Meeting:	October 7, 2015	Open Space:	0.4207 acres (Block A-6)
App. No.:	088-2015-FP	Zoning:	R-1 Residential
Applicant:	West Chase Land Holdings, LLC	Utilities:	Central water & sewer
Engineer:	TGC Engineering, LLC	School Dist.:	Brunswick City
Site Area:	8.5992 acres	Reviewer:	Rob Henwood
Sublots:	17

EXECUTIVE SUMMARY

The subdivision site is located east of Marks Road, west of Substation Road, and north of Center Road (S.R 303) (see location map). The Final Plat for Phase 6 substantially conforms to the Revised Preliminary Plan approved in April of 2014.

West Chase Landings Subdivision Phase 6

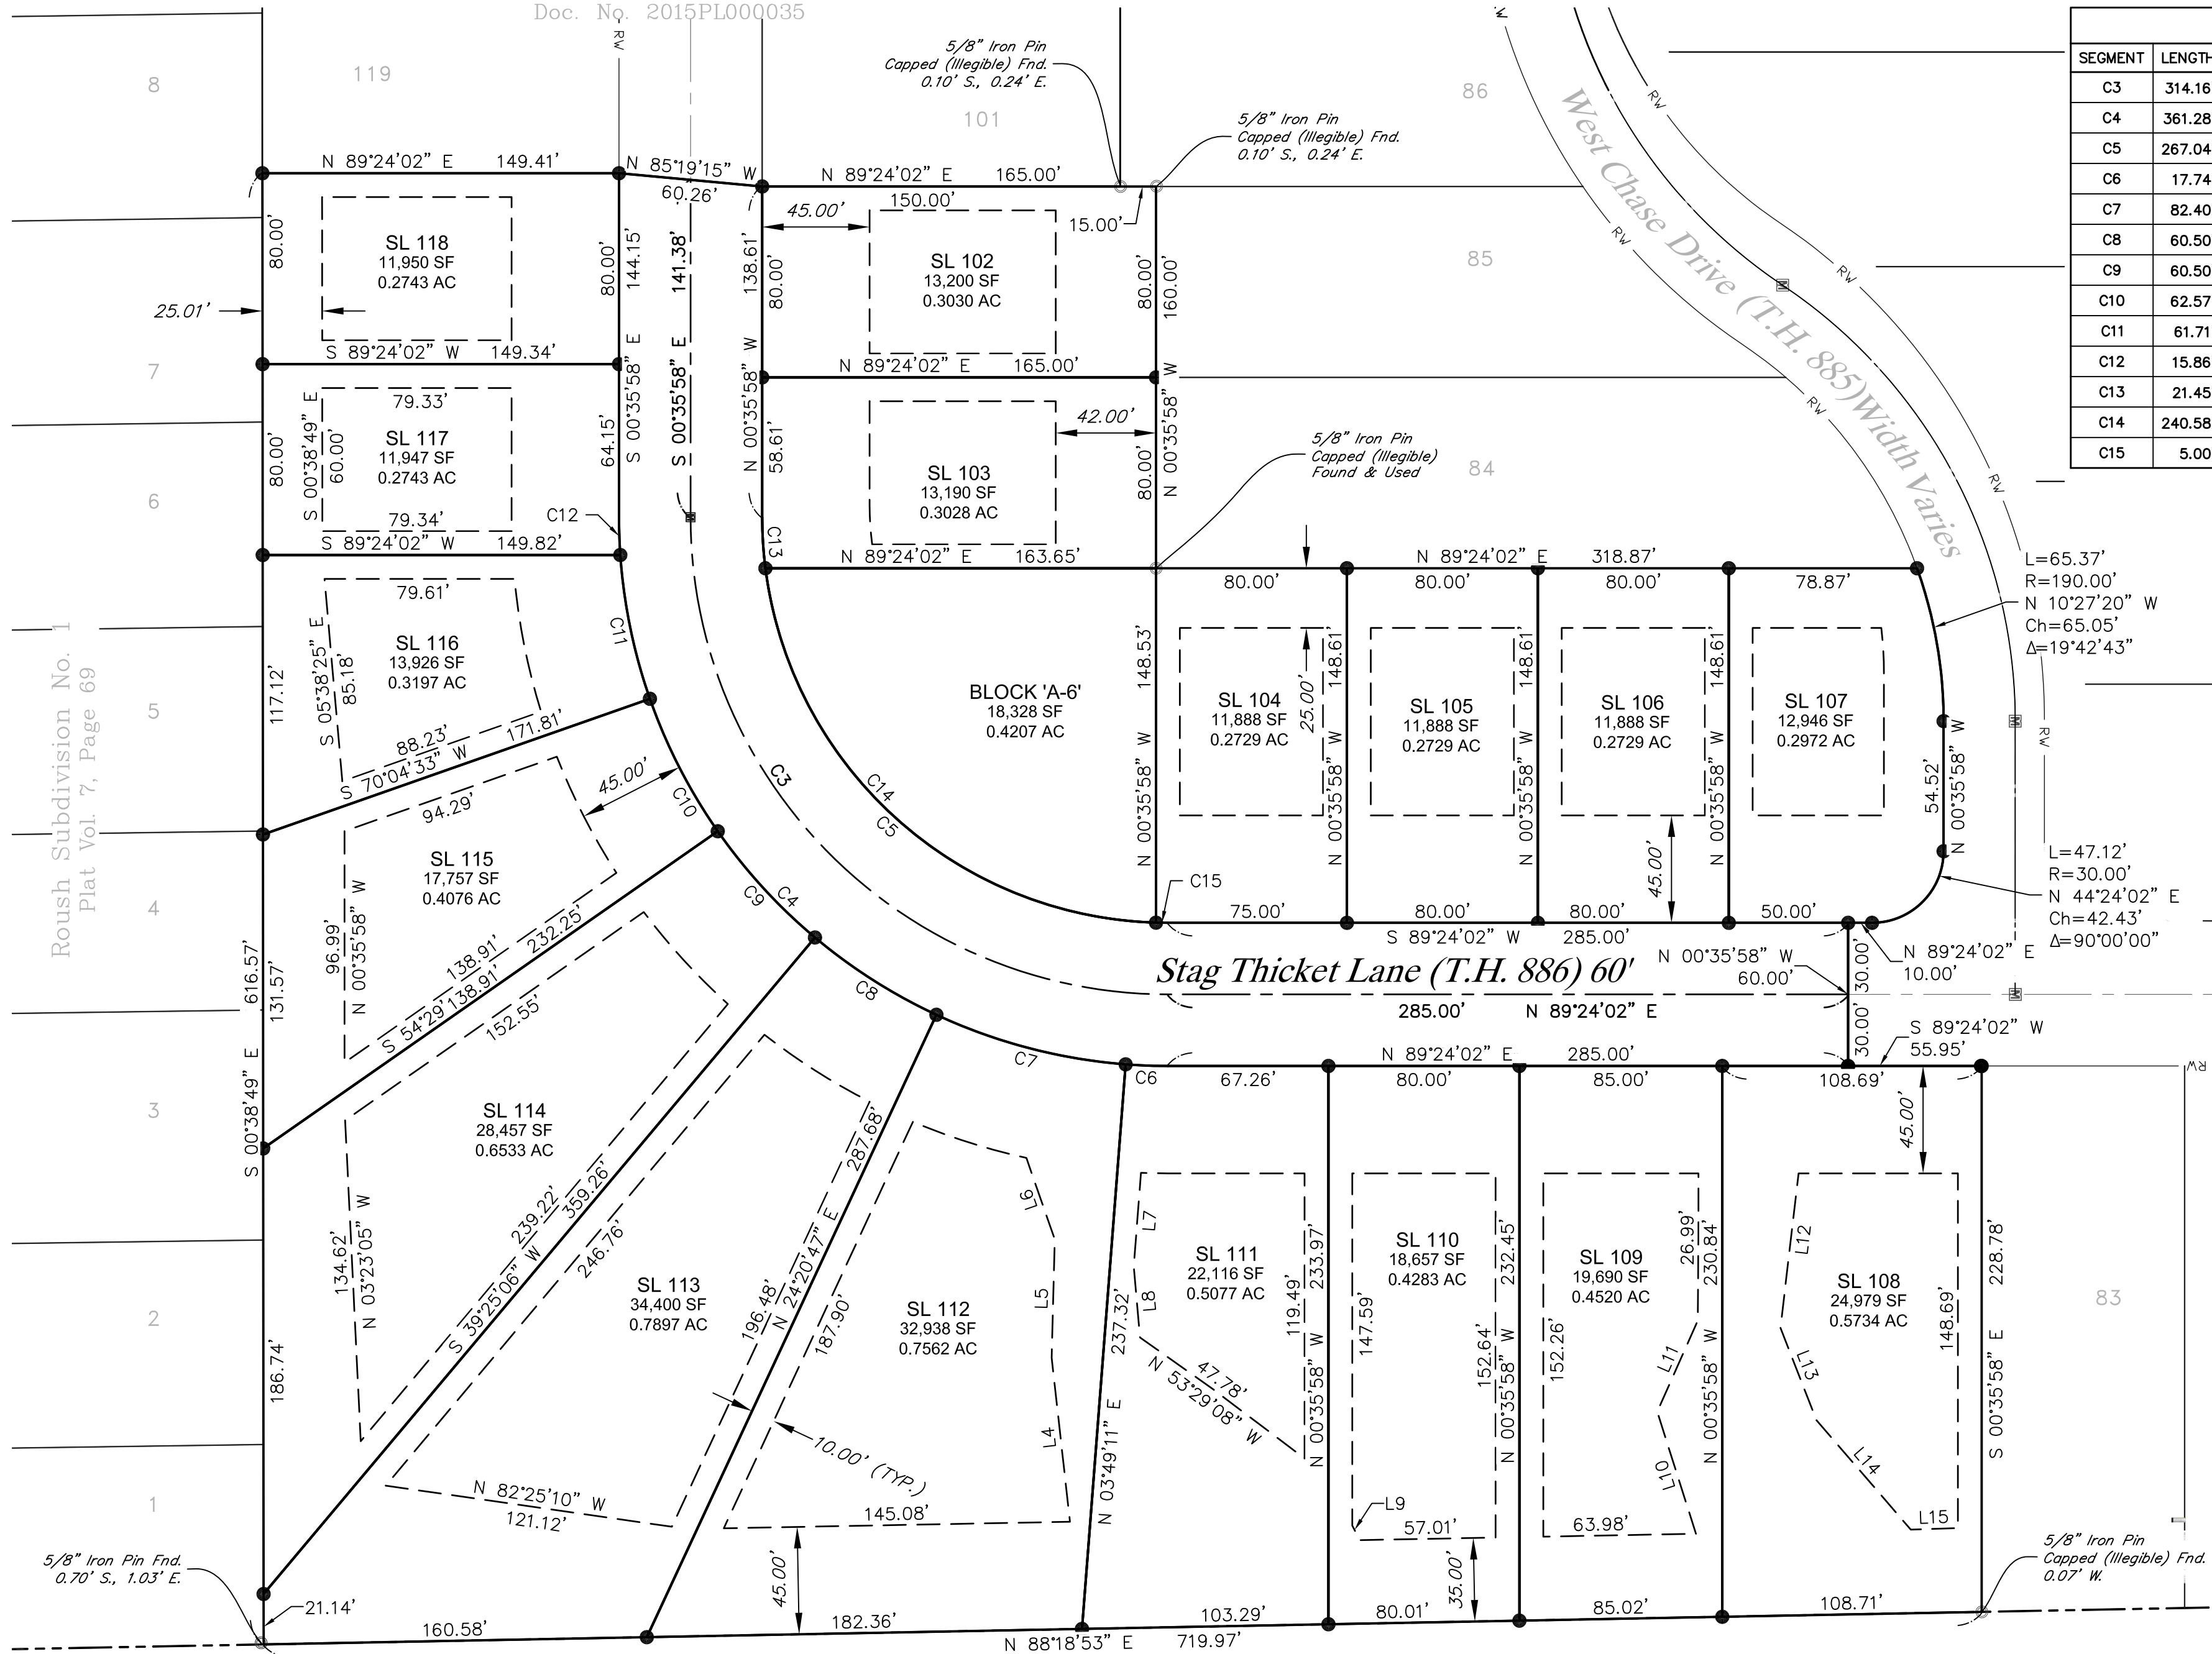
1. *New Block number should be C-5 instead of A-6.*
2. *North arrow is wrong on pages 3 and 4. Layout should be flipped, so north is at top of page.*

TGC Engineering, LLC
 1310 Sharon Copley Road, P.O. Box 37
 Sharon Center, OH 44274
 P 330.590.8004 F 888.820.8423
 Job No. 1375, Page 4 of 4

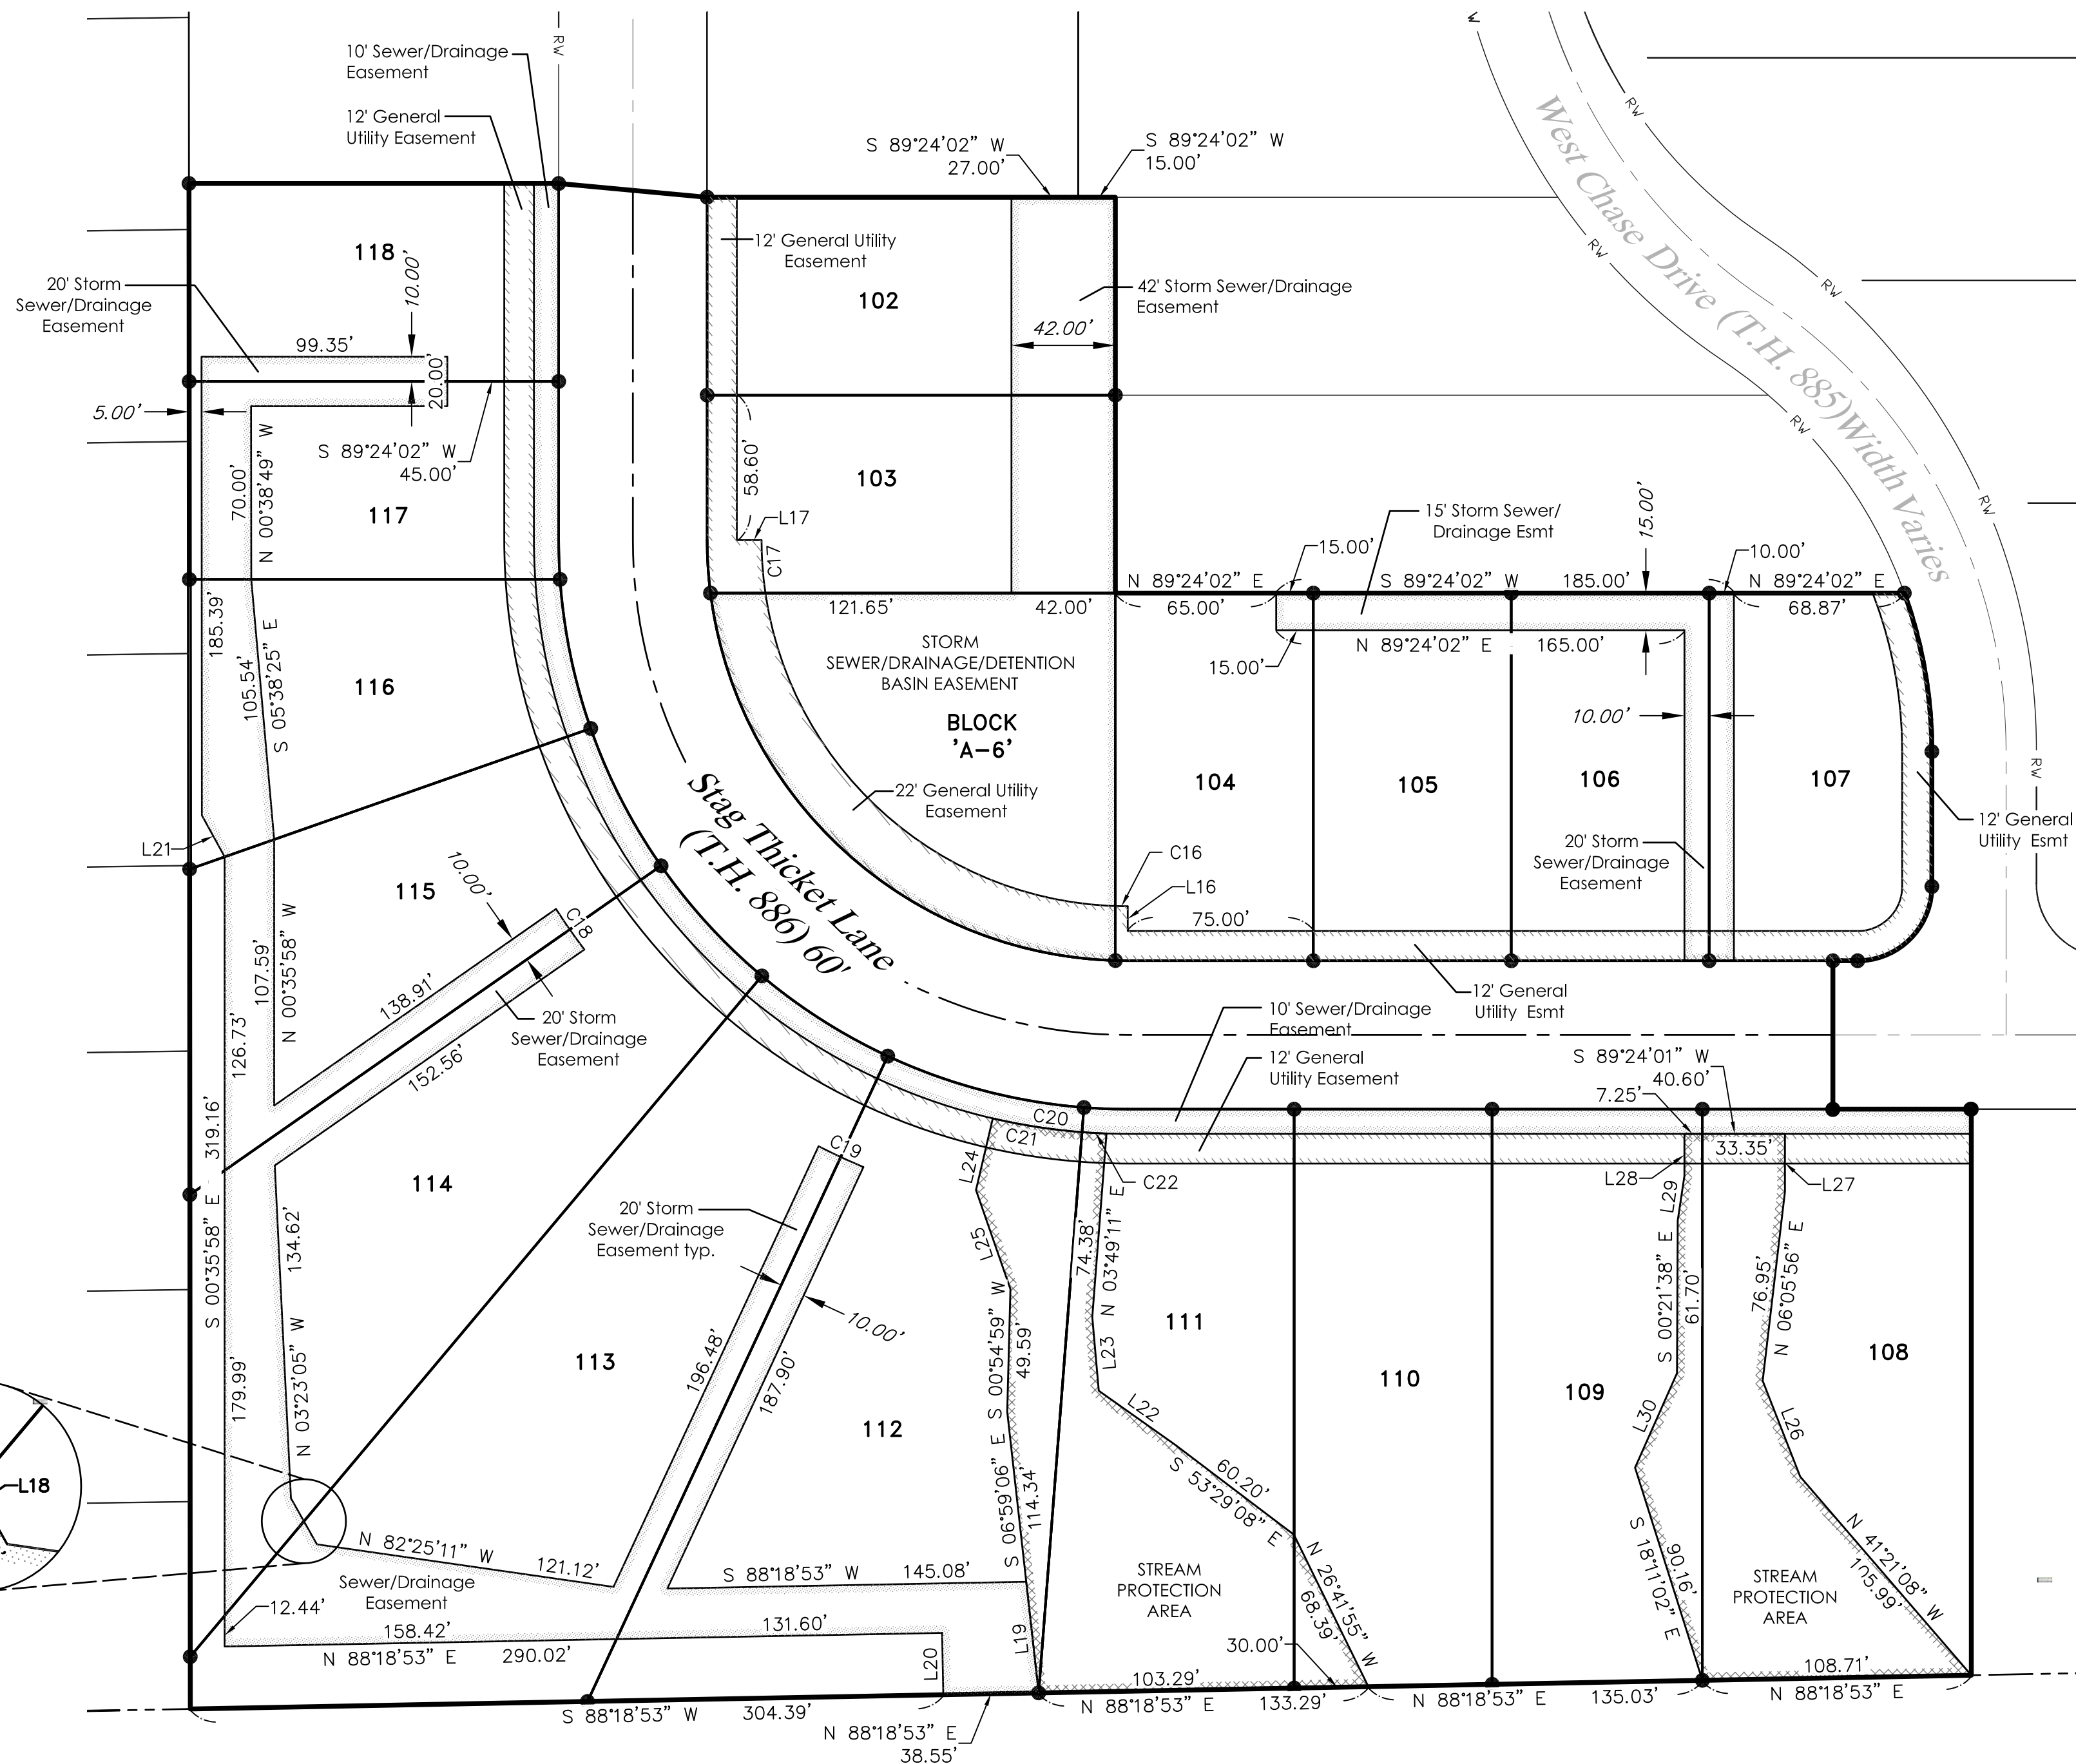
Medina County Sanitary Engineer, Jeremy Sinko, 9/10/15. *APPROVED. Page 4 is incorrectly labelled “West Chase Landings Subdivision Phase 5” when it should be Phase 6.*
